**Verification and certification report form for CDM project activities
(Version 01.0)**

VERIFICATION AND CERTIFICATION REPORT

Title of the project activity	Luohe MSW Landfill Site LFG Recovery to Power Project
Reference number of the project activity	5238
Version number of the verification and certification report	02
Completion date of the verification and certification report	20/07/2016
Monitoring period number and duration of this monitoring period	2 nd Monitoring period 01/04/2013-29/02/2016 (first and last days included)
Version number of monitoring report to which this report applies	02
Crediting period of the project activity corresponding to this monitoring period	10-years fixed crediting period is from 07/10/2011-06/10/2021
Project participant(s)	Shanghai BCCY New Power Industry Co.,Ltd (Project owner) UPM Umwelt-Projekt-Management GmbH (Buyer)
Host Party	China
Sectoral scope(s), selected methodology(ies), and where applicable, selected standardized baseline(s)	Sectoral scope 01: Energy industries (renewable/non-renewable sources) selected methodology : AMS-I.D: Grid connected renewable electricity generation - Version 16.0 Sectoral scope 13: Waste handling and disposal

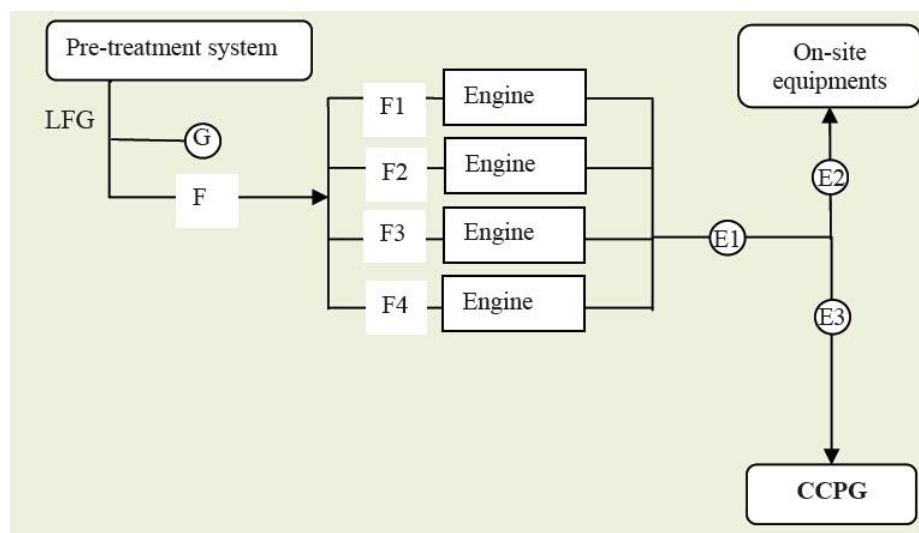
[Metering System] The monitoring system has been checked onsite by the verification team and has been confirmed to be in compliance with the registered PDD. The line diagrams are shown in below:

Flow meter (F) and flow meters (F1~F4) monitor the total amount of landfill gas captured and fed to the gas engines respectively. To be conservative, the monthly minimum of total LFG amount and sum of LFG to engines 1#, 2#, 3#, 4# will be used for ER calculation.

The cellular gas analyzer (G) monitors the concentration of CH₄ in the LFG. The monitoring data were checked by the operators every day and reported to General Manager by CDM manager monthly.

$EL_{LFG, y}$ - Total amount of electricity produced by all engines in the year y. The electricity produced by all engines in the project is continuously measured by the electricity meter E1 (0.5s) installed at the low voltage side of the on-site transformer substation.

The electricity consumed by the project is continuously measured by the electricity meter E2 (0.5s) installed at the low voltage side of the on-site transformer substation.

The electricity meter E3 (0.5s) is installed at the control room of project site
